**WATTS BAR NUCLEAR PLANT (WBN) UNIT 1 - AMERICAN SOCIETY OF
MECHANICAL ENGINEERS (ASME) SECTION XI, INSERVICE INSPECTION
(ISI) PROGRAM RELIEF REQUEST 1-ISI-07 THROUGH 1-ISI-12 - REQUEST
FOR ADDITIONAL INFORMATION (TAC NO. MB1274)**

**WATTS BAR NUCLEAR PLANT UNIT 1
INSERVICE INSPECTION PROGRAM RELIEF REQUEST 7 THROUGH 12**

REQUEST FOR ADDITIONAL INFORMATION

REVISED INSERVICE INSPECTION REPORT R-0569

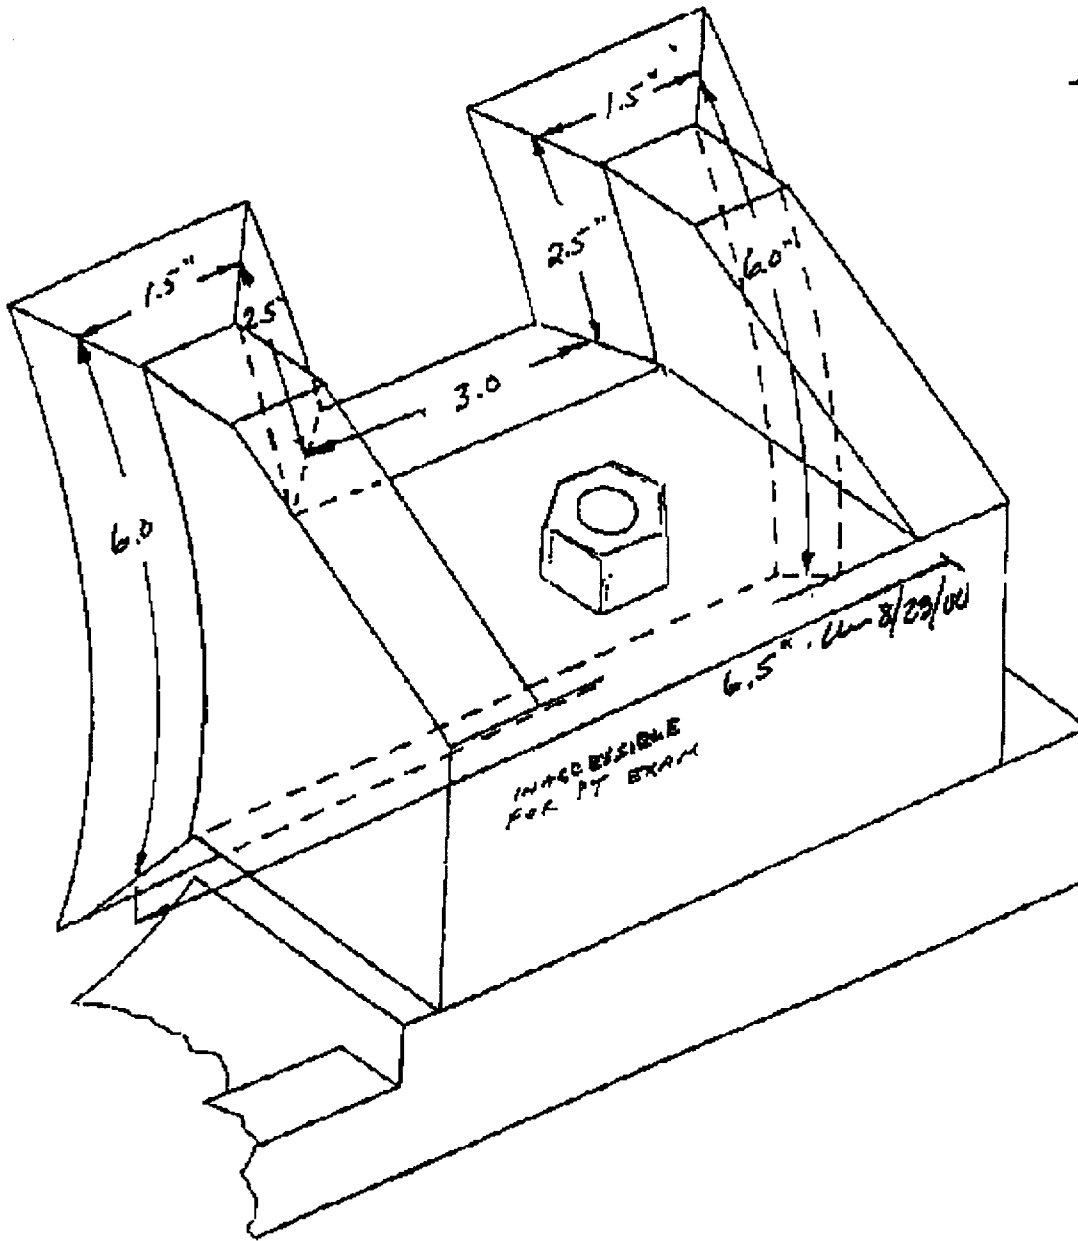
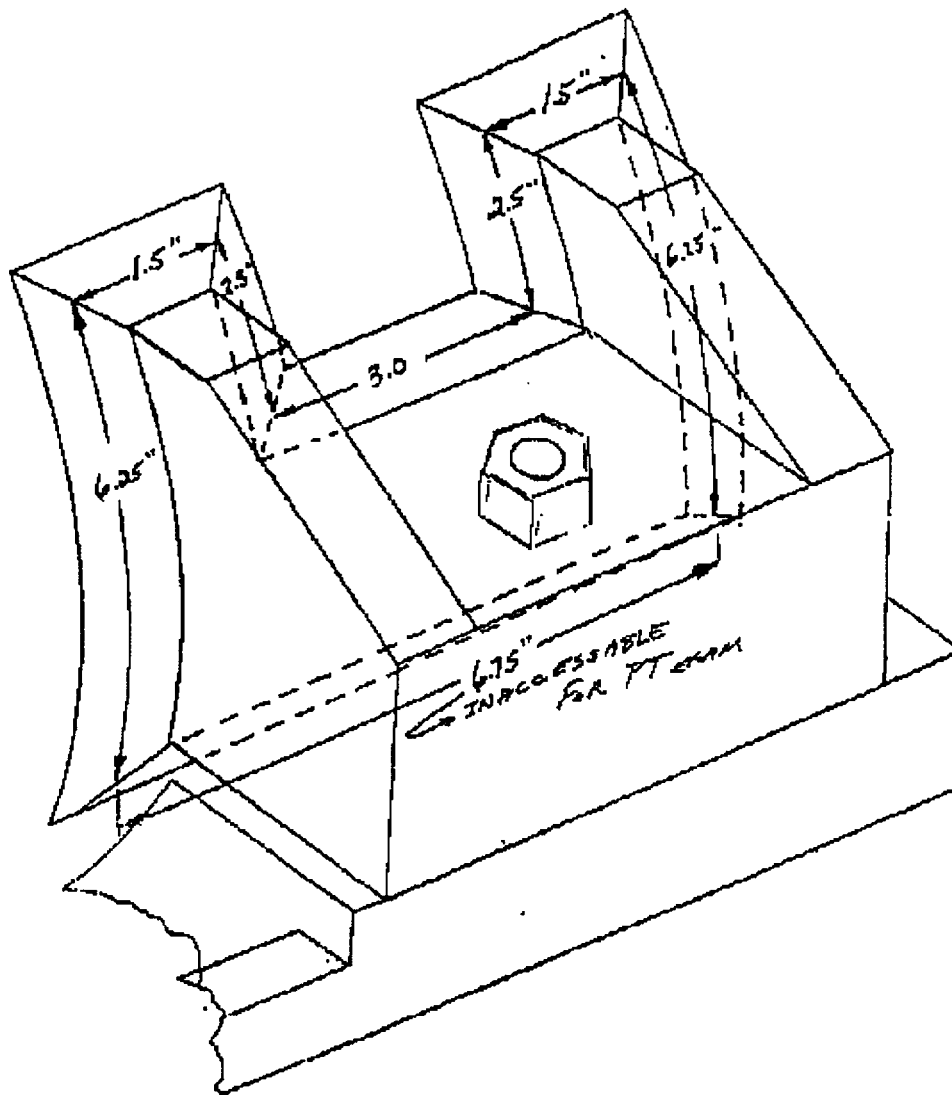
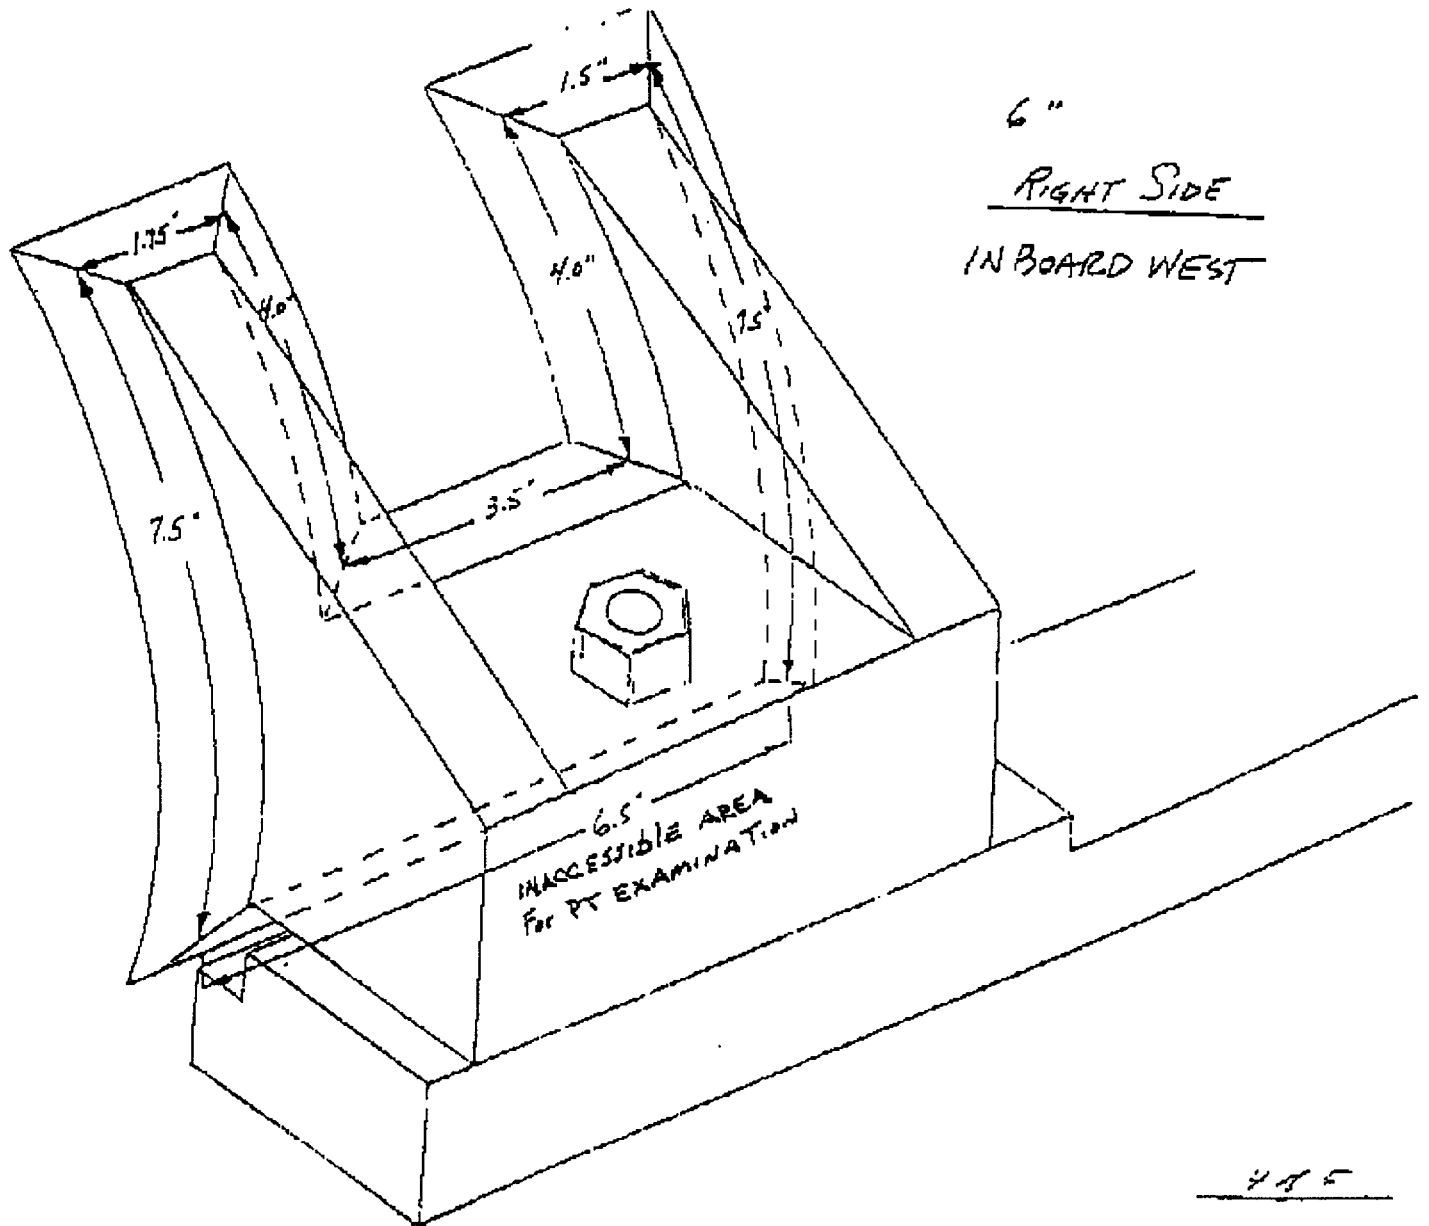
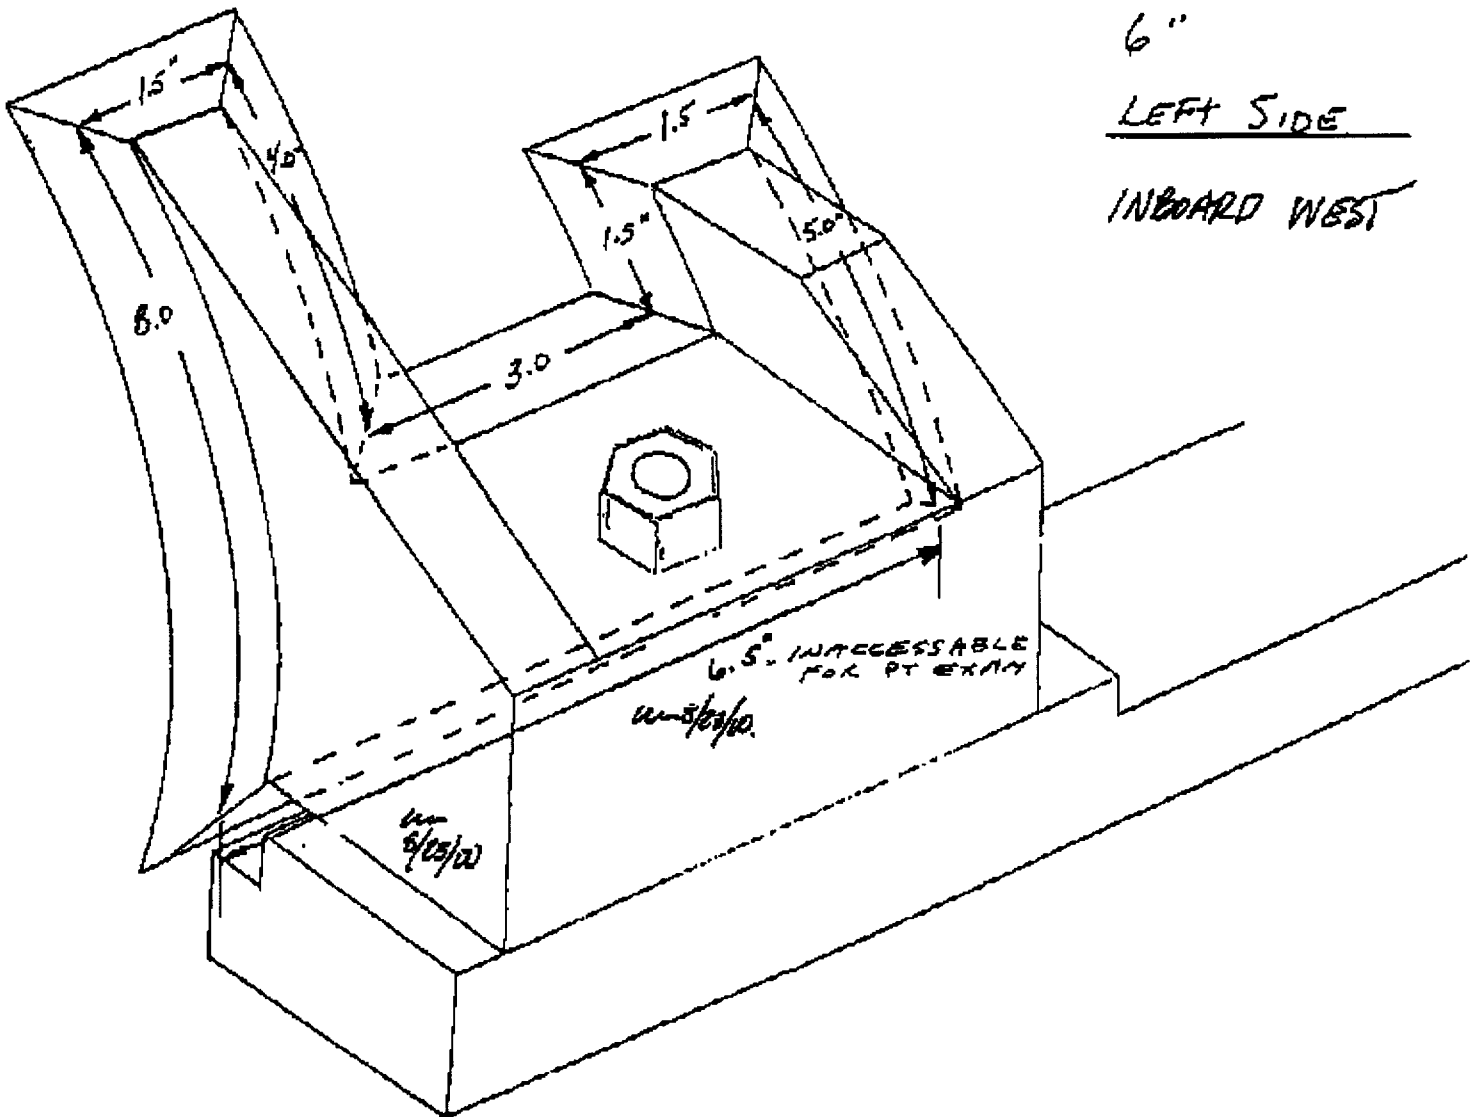
- (a) It is clear from the drawing ISI-0118-C-01 (Attachment 1) that both pumps 1A-A and 1B-B are identically installed and operated. The sketches included in the Attachment 3 belong to pump 1B-B, while record of liquid penetrant Examination Report, R-0569, indicates weld ID CCPH-1A-A-IA. Clarify the discrepancy. Also, the relief is requested for the pump 1A-A. Provide the sketches for the pump 1A-A.
- (b) Based on the four sketches in Attachment 3, the total accessible area is 26.25 inch in total length of the weld is 127.5 inch. Therefore, the length of weld examined is 101.25 inch while the Liquid Penetrant Examination Report R-0569 indicated in its comments that the total length of weld examined is 107.25 inch. Clarify this discrepancy.

- (a) The sketches in report R-0569 were copied from an earlier report on the 1B-B pump. The dimensions and location of the attachments were revised for the 1A-A pump but reference to the 1B-B pump was not removed. The sketches in report R-0569 have been revised for pump 1A-A and are included in Attachment 1 of this Enclosure.

- (b) A further review of the four sketches in Enclosure 1, Attachment 3 of the February 21, 2001 request for relief reveals the length of welds to be 29.5-inches, 30.25-inches, 36.25-inches, and 31.0-inches, respectively, for a total of 127.0 inches. The inaccessible areas were 6.5-inches, 6.75-inches, 6.5-inches, and 6.5-inches respectively for a total inaccessible area of 26.25 inches. The weld area receiving the penetrant testing (PT) examination should be indicated as 100.75-inches and not the 107.25-inches as indicated on Report R-0569. Based on this review the actual coverage achieved should be shown as approximately 80%, and not the 84% as indicated in the February 21, 2001, submittal. The report has been revised as shown in Attachment 1 of this Enclosure.

Photo 1
Inaccessible Areas

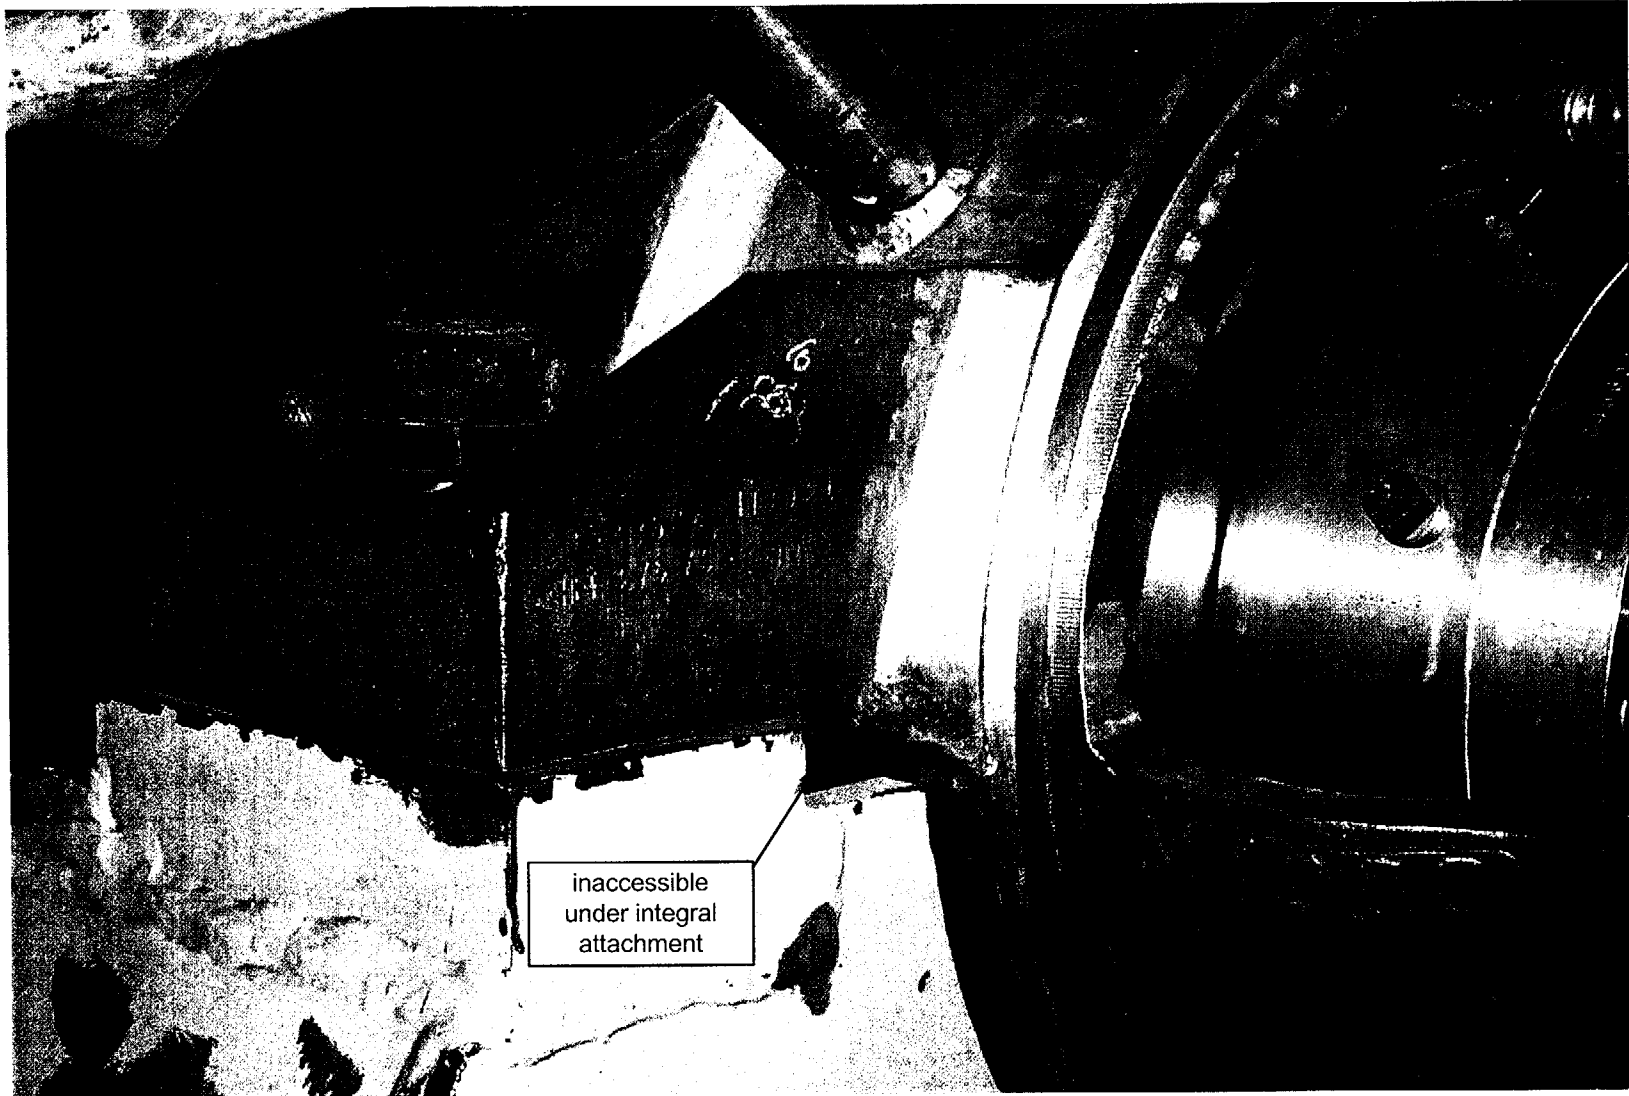
The sketches provided in the Attachment 3 are not clear about the inaccessible area for PT exam. Provide some photos or actual drawings indicating the inaccessible areas.

Photos of the inaccessible area are included in Photo 1 and 2 of Attachment 2 of this Enclosure. The inaccessible area is under the integral attachment and behind the pump support. Note - since WBN Unit 2 is in a deferred status, photos are of the Unit 2 pump which has a similar configuration as the 1A-A pump. The Unit 2 pump which is located in a separate room is not contaminated, therefore, with no dose in the room, the pump is more accessible for photos than the Unit 1 pump.

Photo 2
Inaccessible Areas

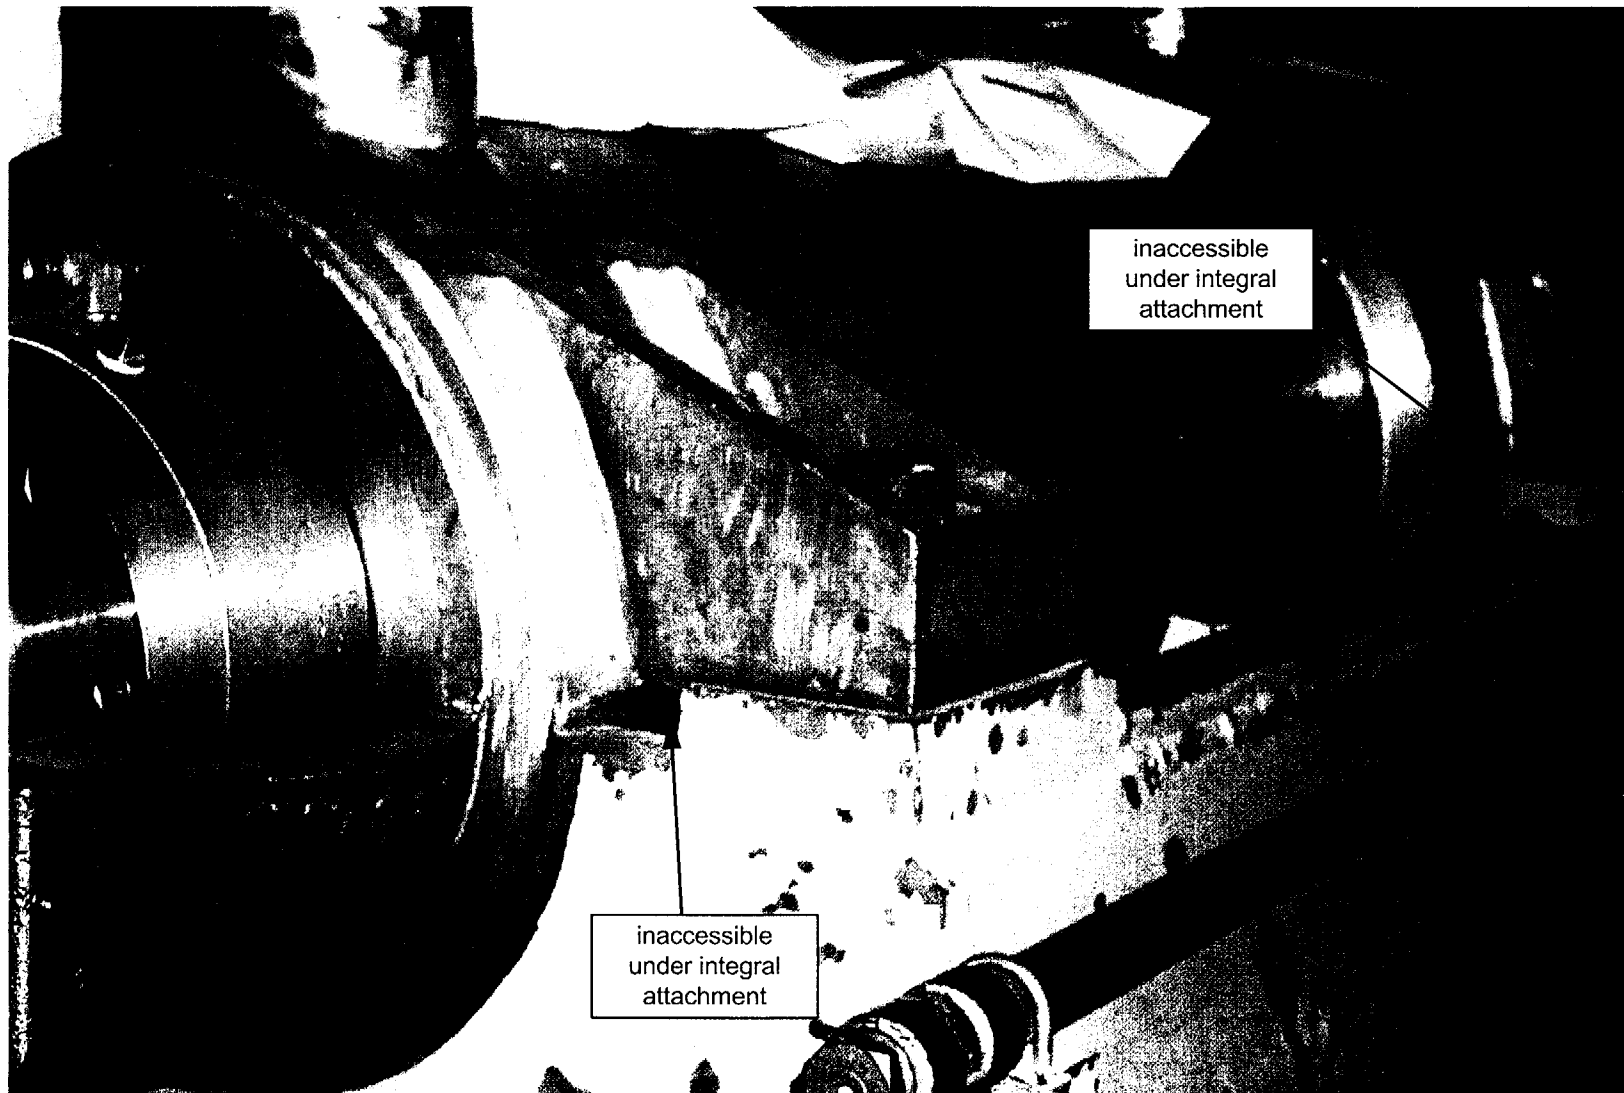
- (a) "Connecting piping would have to be disconnected and pump disassembled and lifted to allow access to the remaining 16% examination area." Clarify which piping and demonstrate with photos why the pump has to be disassembled.
- (b) "The bottom side of the attachment is inaccessible due to a support which bolts the pump to the supporting frame." Illustrate how the bolt is interfering with the PT exam.
- (c) "Other NDE techniques were considered;..." What other NDE techniques were considered.
- (d) "The maximum...and adjacent metal of the subject weld provides reasonable assurance of an acceptable level of quality and safety." Illustrate the adjacent metal of the subject weld.

- (a) The piping requiring disassembly is the inlet and outlet pump piping as shown in Photo 3 of Attachment 2. To obtain access to the inaccessible portion of the weld, this piping would be required to be disassembled, the pump uncoupled from the motor and the pump lifted off the pump support.
- (b) Refer to Photos 1, 2, and 3 in Attachment 2. It is not a bolt which interferes with the PT examination, but the configuration of the pump "bolted" to the support. As noted in the photos, the cylindrical pump housing is "cradled" on the pump support with the subject integral attachments

bolted to the pump support. The curvature of the pump support follows the curvature of the pump housing preventing access to the bottom weld of the integral attachment.
